Technical Advisory Committee

Meeting Minutes

June 1, 2023

Aspen Storage's request for review and approval of a Development Plan for an expansion of Ameri-Stor Self-storage at 8789 N 600W

Existing Conditions

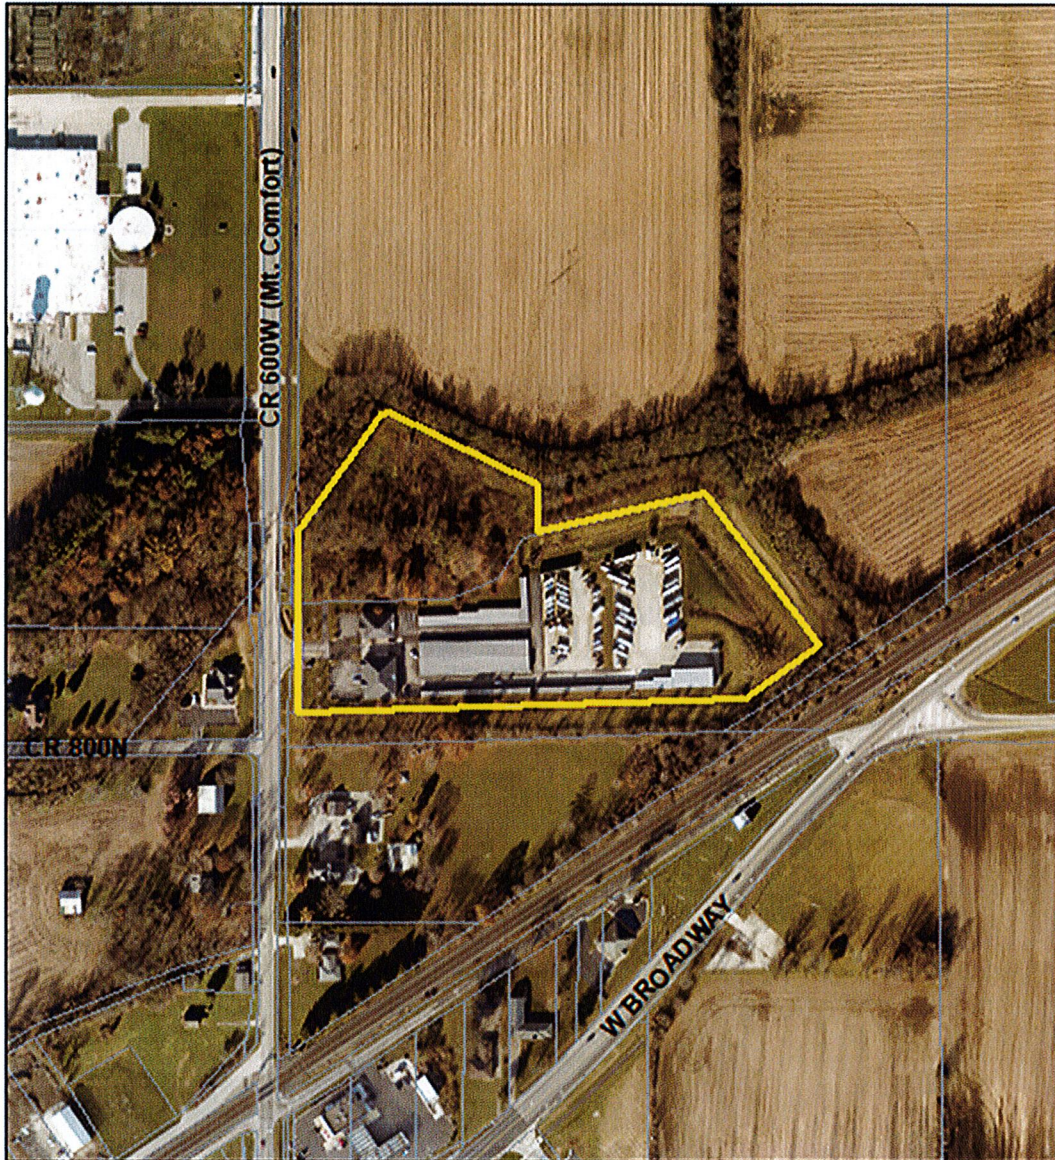
1. Landscaping plans were not filed. This project is required to submit landscape plans.
2. The Special Exception and Variances that were approved were approved for single-story storage buildings. The filed plans seem to indicate 2-story. This is an issue that we will need to discuss.
3. The "buffer-yard" is not annotated.
4. Fencing between the new buildings is not annotated. Please add annotation that ensure the fence is in keeping with the BZA approval.
5. Fencing is not shown as required by the BZA approval. The BZA's conditions of approval require a min. 8' tall wood or composite privacy fence around the outdoor storage area, all rear parking areas, and behind the new buildings. Please show this fence in all such locations and annotate the fence type and height.
